OBJECTIONS to proposed extensions and alterations to the ORT premises.

David Jenkin, 157 Arlington Road NW1

06-12-2017

Proposed ORT development and roof extensions

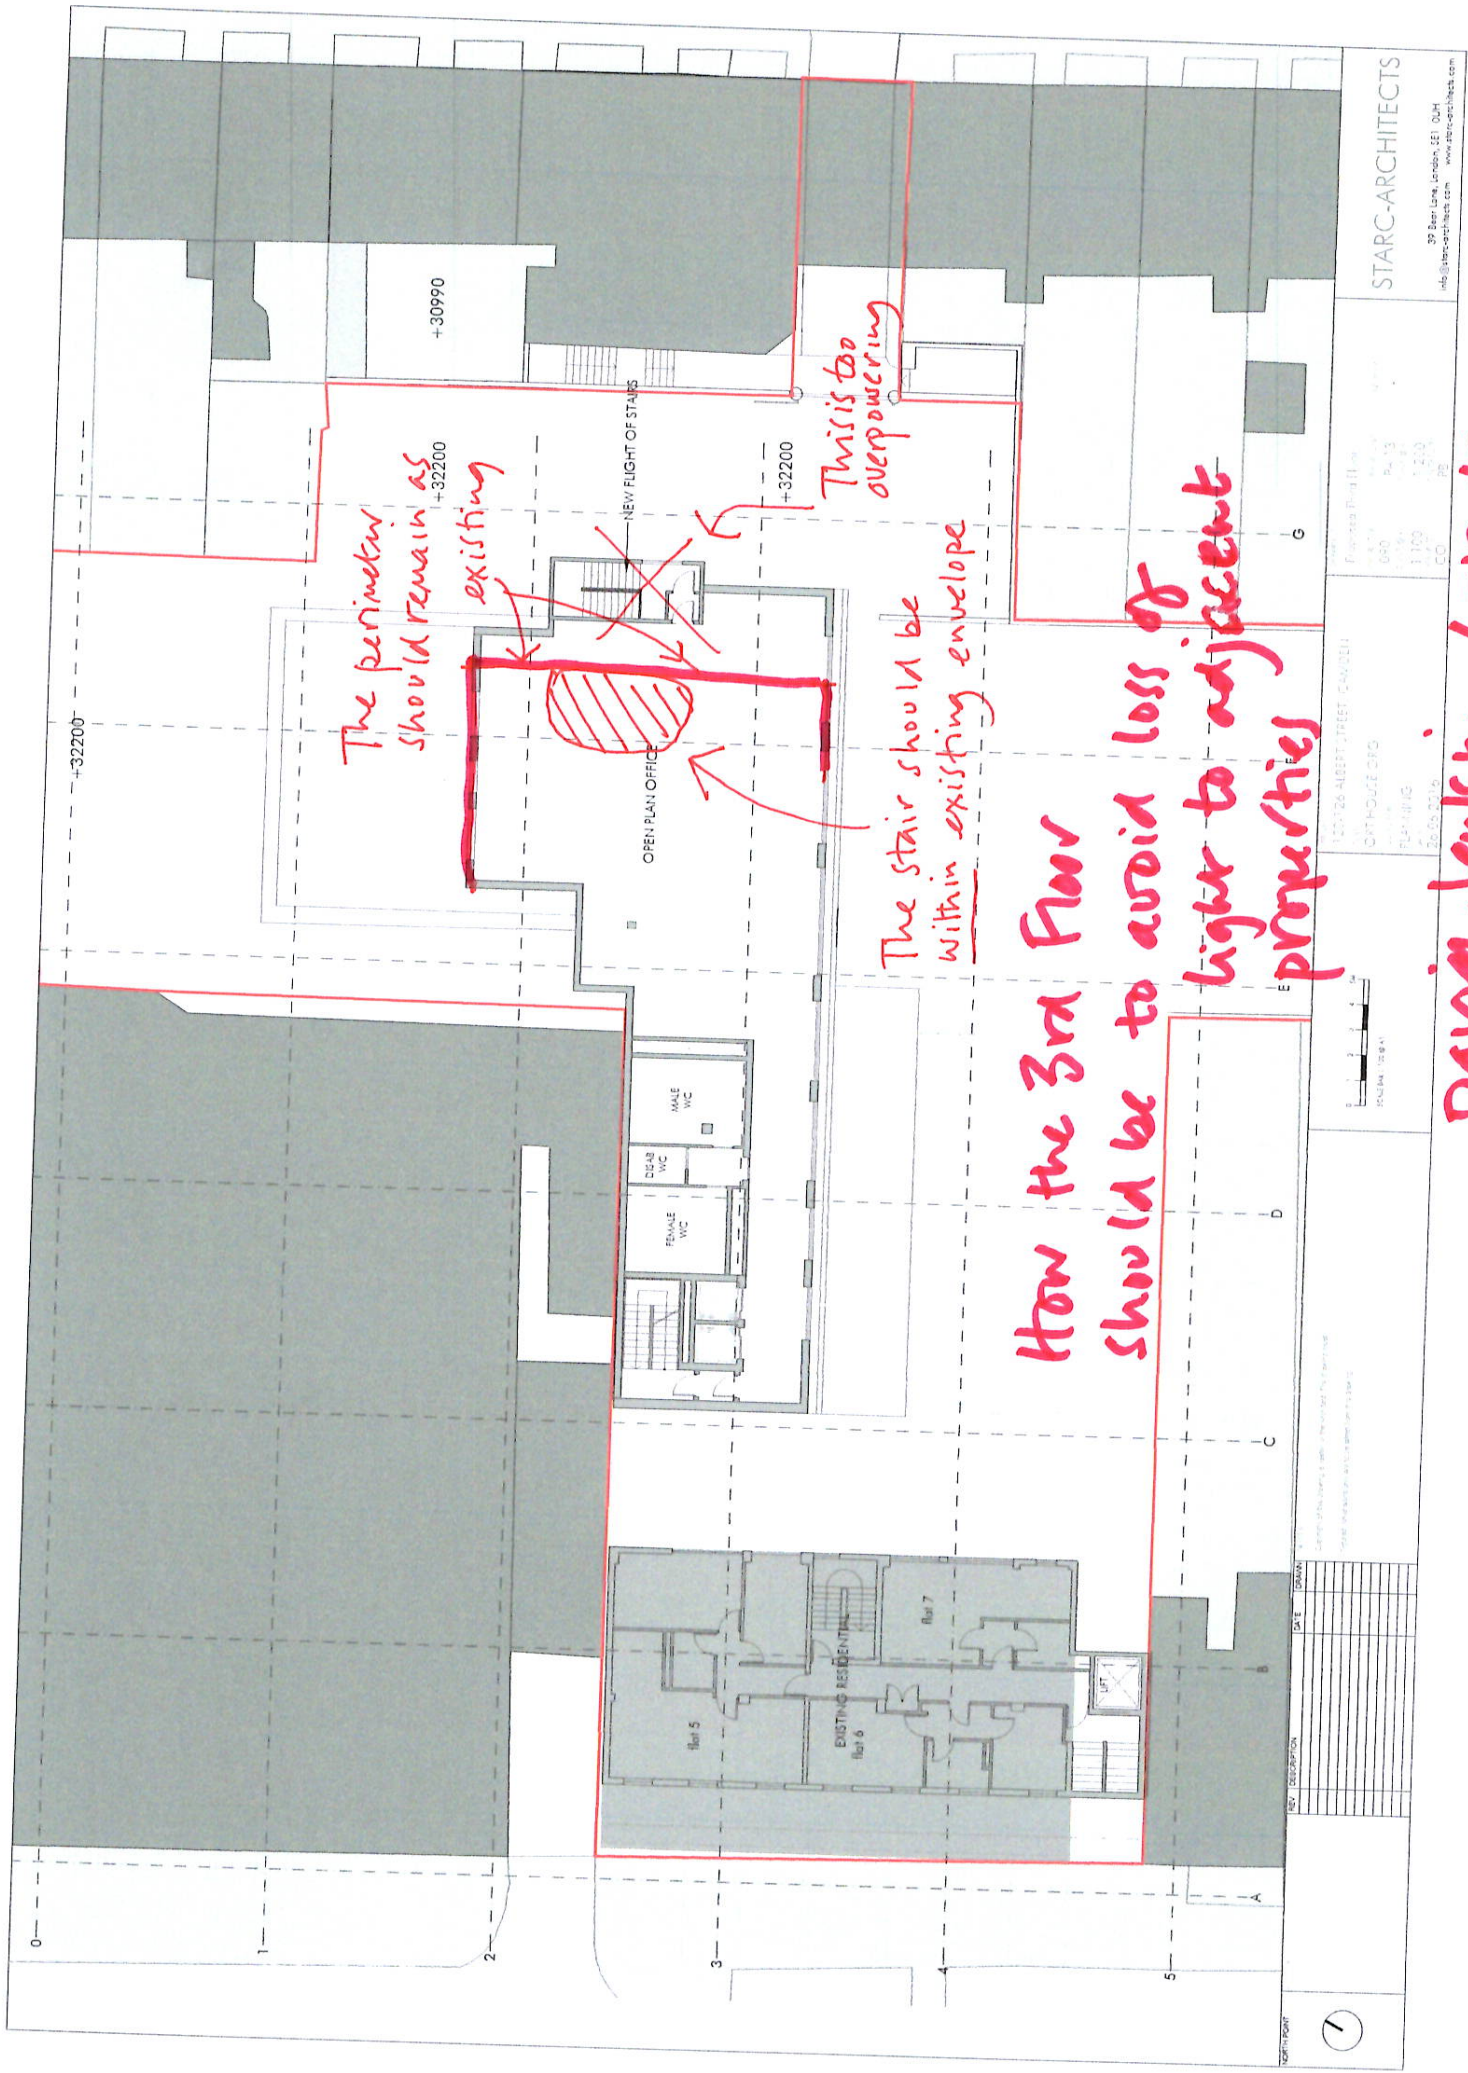
The perimeter should remain as existing

This is too overpowering

The stair should be within existing envelope

How the 3rd Floor should be to avoid loss of light to adjacent properties
